WCAP-16793-NP, Rev.0 (Non-Proprietary)
Project No. 694

March 2, 2009

OG-09-84

Subject: Pressurized Water Reactor Owners Group
Responses to the NRC Request for Additional Information (RAI) on WCAP-16793-NP, "Evaluation of Long-Term Cooling Considering Particulate, Fibrous and Chemical Debris in the Recirculating Fluid" (PA-SEE-0312)

Figure 1: Integrated Core Flow vs. Core Boil-off for Channel 13 Flow Reduction 50%

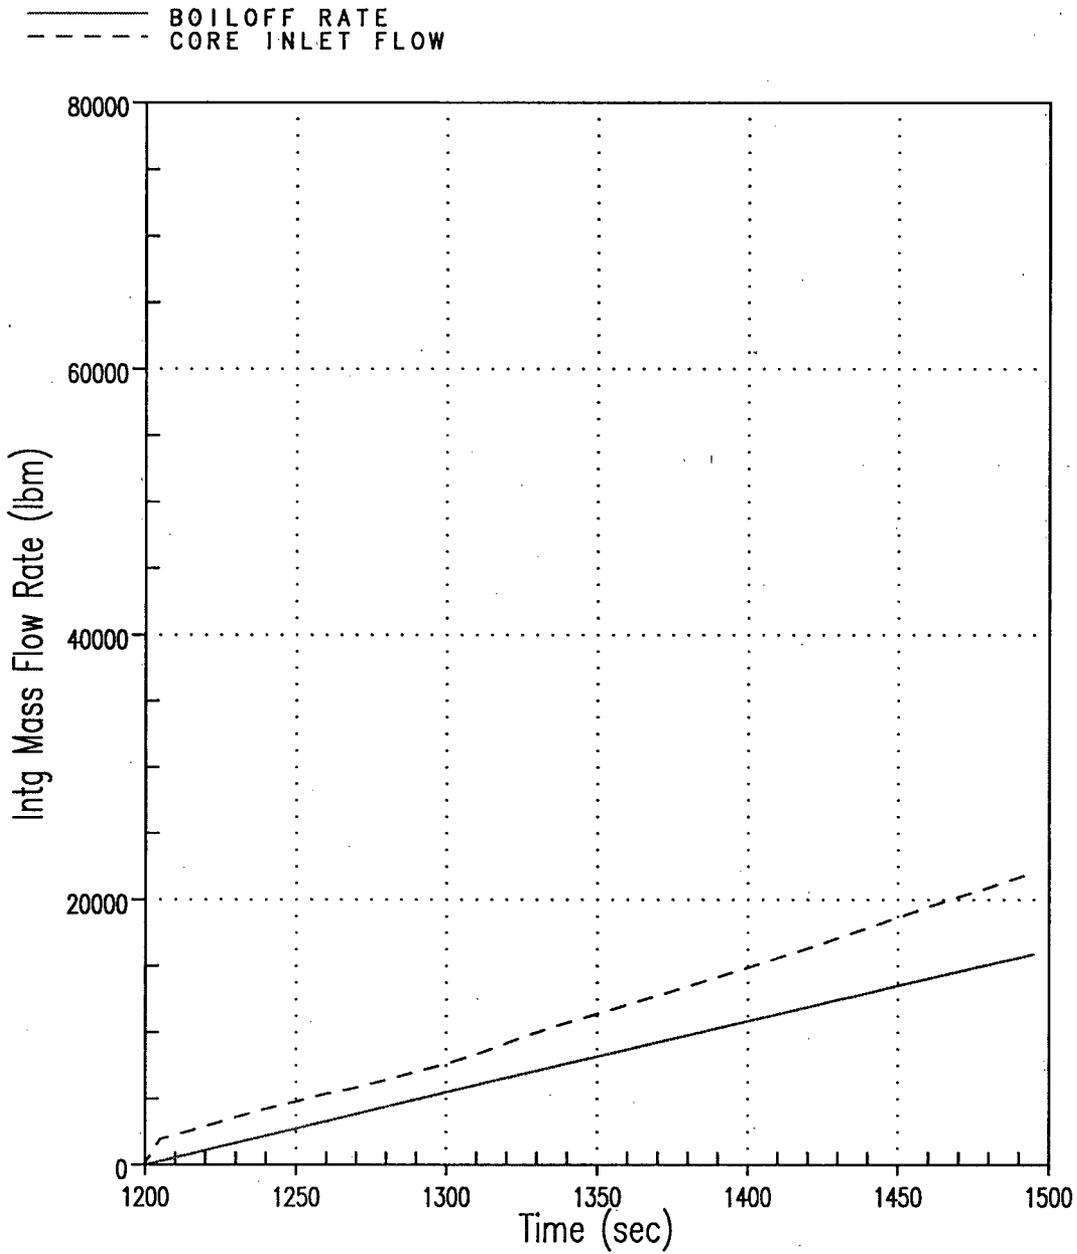
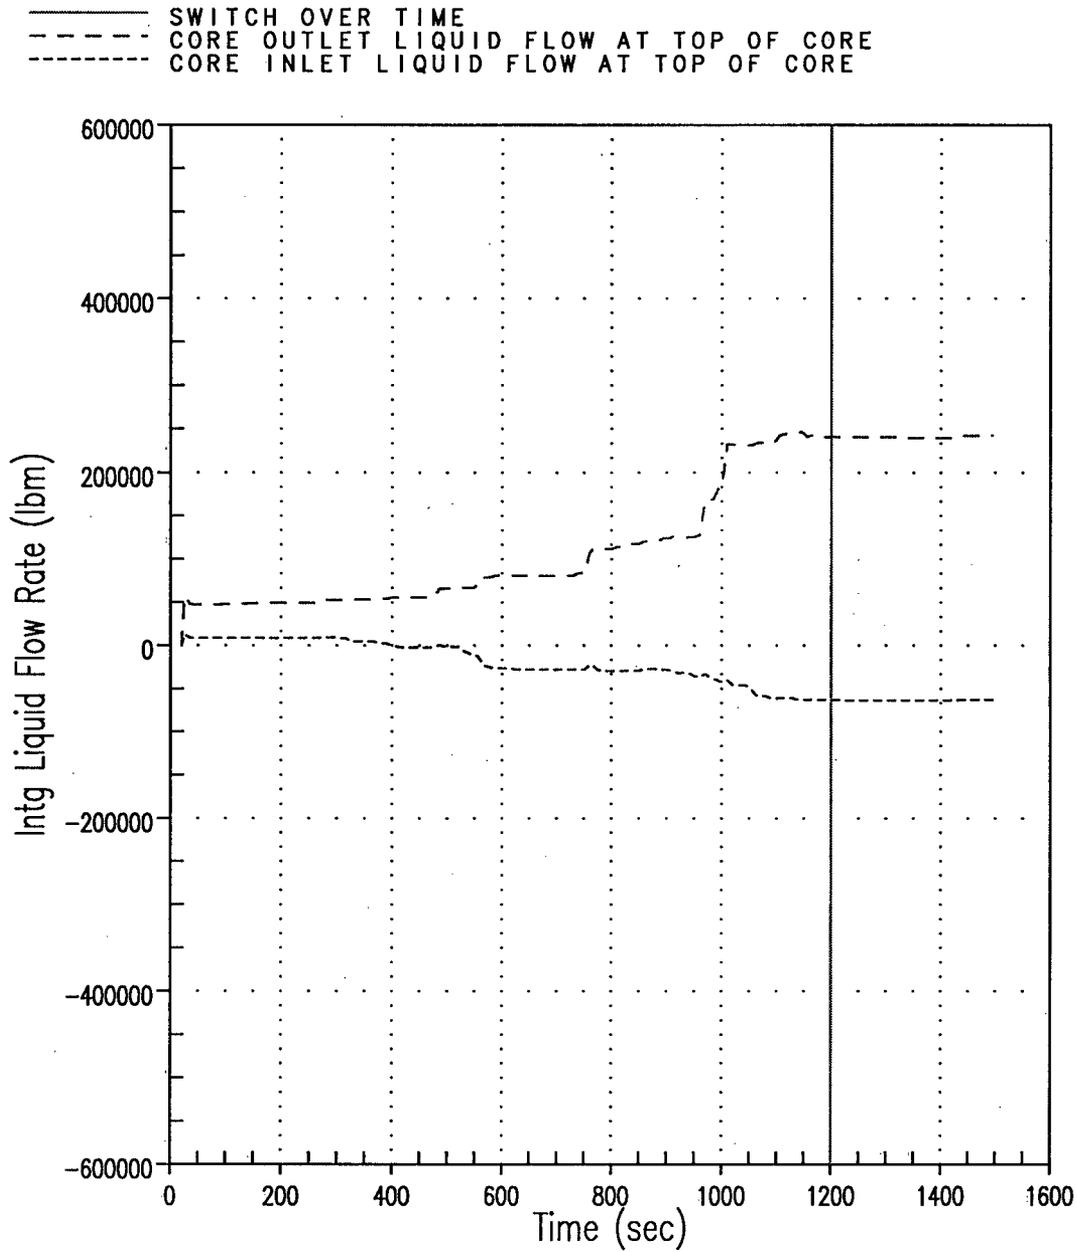
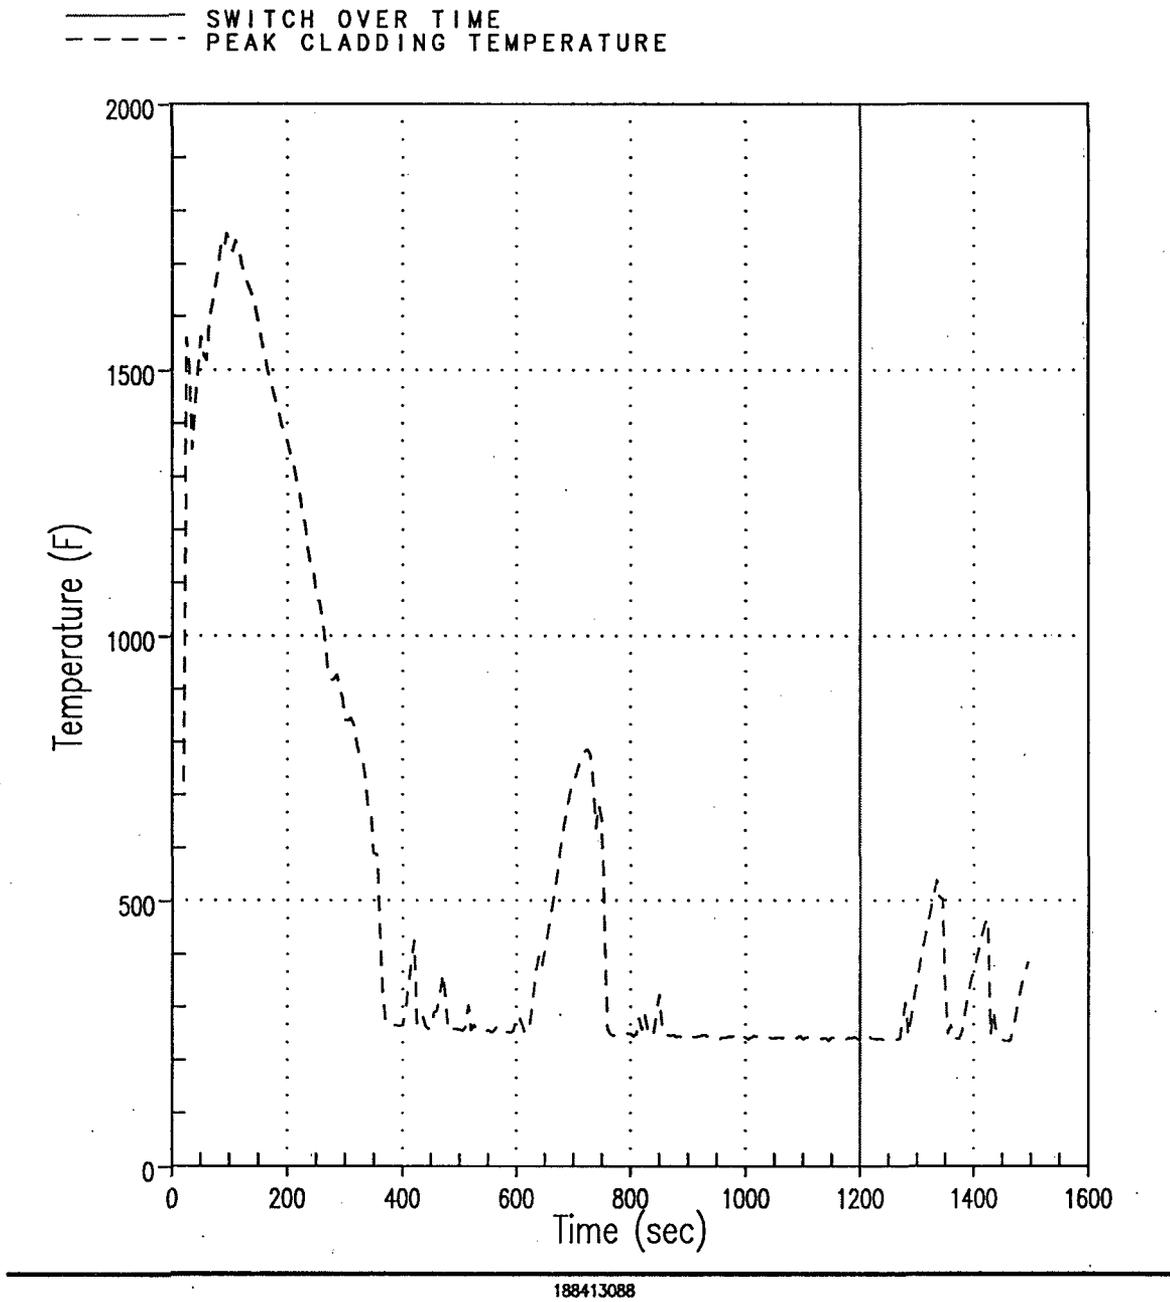
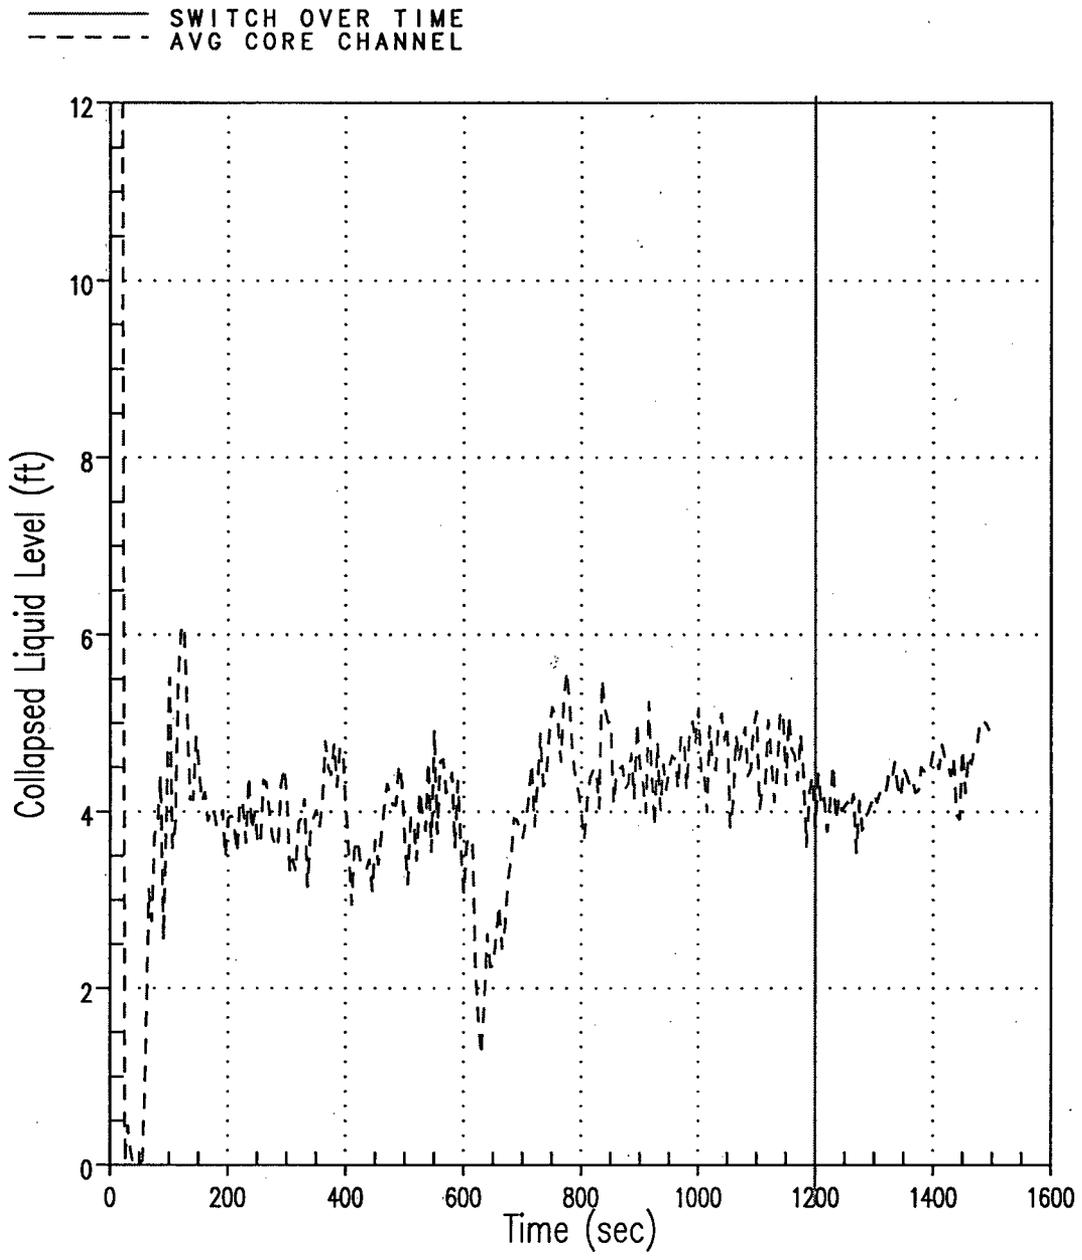
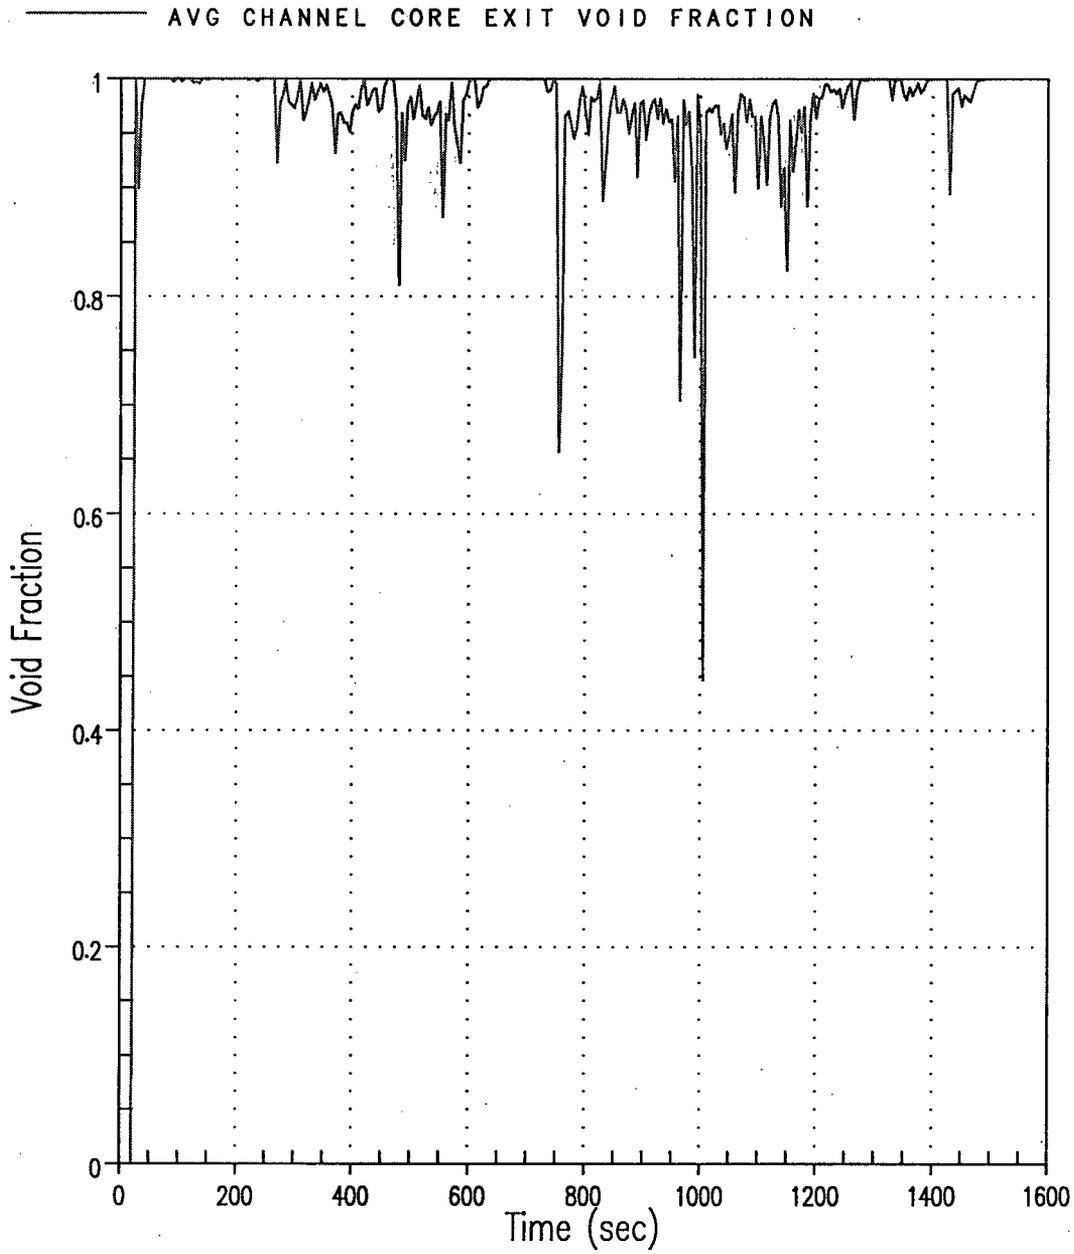
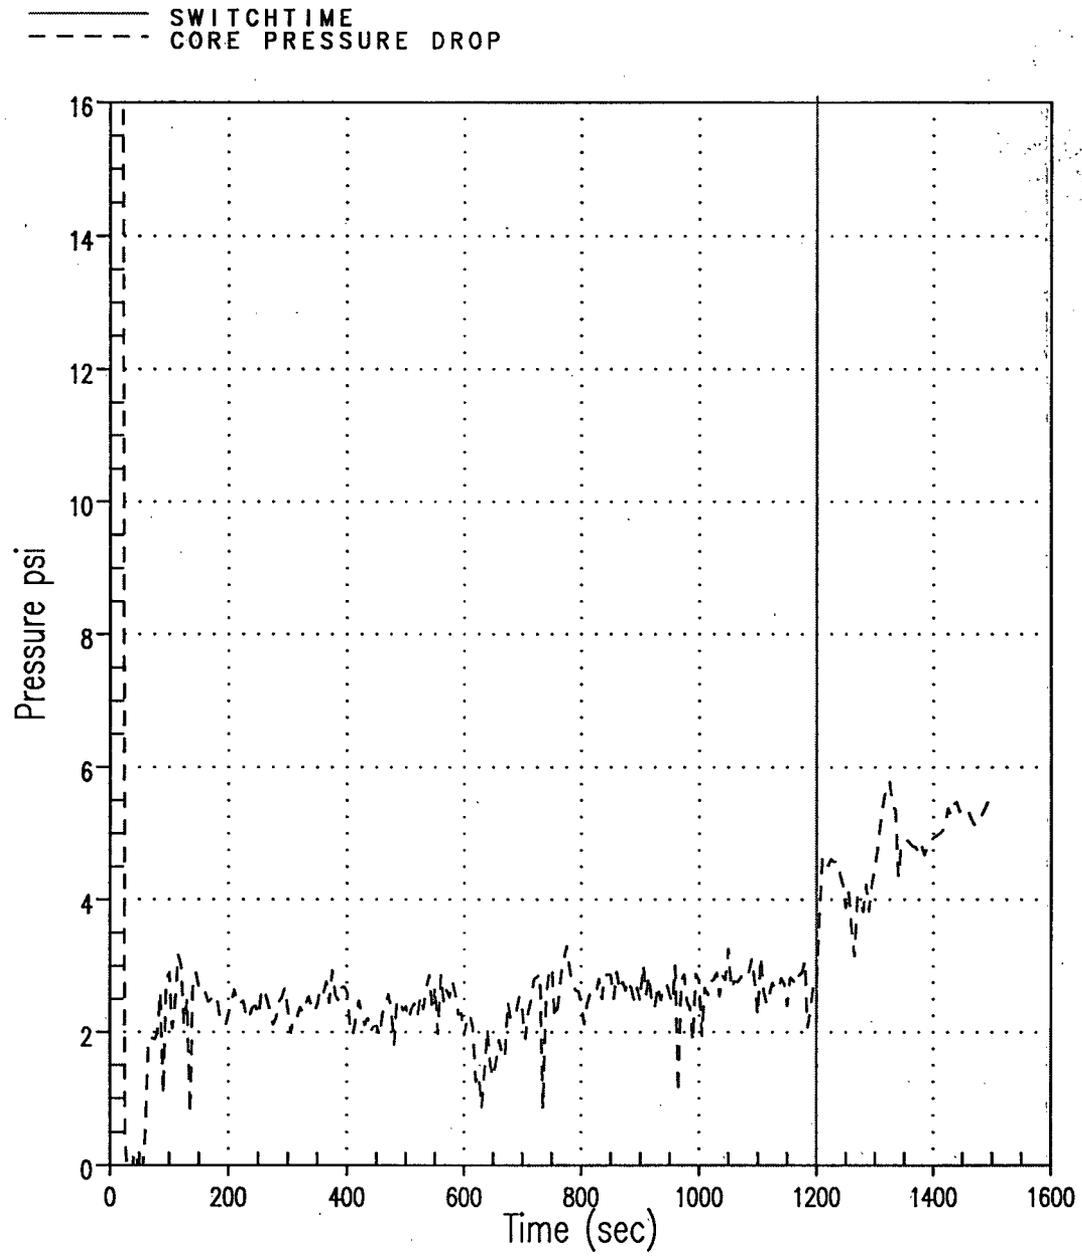
- 1) WCAP-16793-NP, Appendix B, presents analyses of the effect of core inlet blockage using the WCOBRA/TRAC analysis code. Since the report was prepared additional analyses have been performed to determine the blockage level that would reduce core flow below that necessary to match coolant boil-off. Please provide documentation of the additional analyses that have been performed, including figures, for the integrated core inlet and exit flow, peak cladding temperature, core collapsed liquid level, core exit void fraction, and core pressure drop for the bounding conditions. The results should be presented for each case analyzed up to and including the blockage level for which boiloff is no longer satisfied.

The first flow reduction run performed reduced the hot channel (Channel 13) flow area by 50%, which yields a total core inlet flow reduction of 99.7% compared to an unblocked core. The requested plots for this case are shown in Figures 1 through 7. Figures 1 and 2 show comparisons of the integrated core inlet flow and the core boil-off rate. As shown, even with the increase in core blockage, the flow that enters the core is still in excess of the boil-off rate. Figure 3 displays the integrated liquid flow at the core exit. The figures illustrate that, although liquid in excess of that needed to keep the core quenched enters the core, every little liquid flow is present at the core exit after the blockage occurs. The Peak Cladding Temperature (PCT) is shown in Figure 4. There are no significant PCT excursions after the core is blocked. Figure 5 displays the collapsed liquid level of the average assembly core channel (Channel 11 of Figure 6.3.4-3 in Reference 1). The figure shows that the collapsed liquid level drops slightly at the time blockage occurs, however, the liquid level continues to increase even after the blockage to the hot channel (Channel 13) is fully implemented at 1230 seconds. The void fraction at the core exit shown in Figure 6 again illustrates that liquid is present at the top of the core which shows the flow that enters the core after blockage occurs is still in excess of the boil-off rate. The core pressure drop is displayed in Figure 7. The figure displays an increased pressure drop of roughly 2 psi as blockage at the core inlet is increased. As the conditions in the Reactor Coolant System (RCS) adjust to increase in core blockage, it is noticed that the core pressure drop fluctuates consistent with the core liquid level.
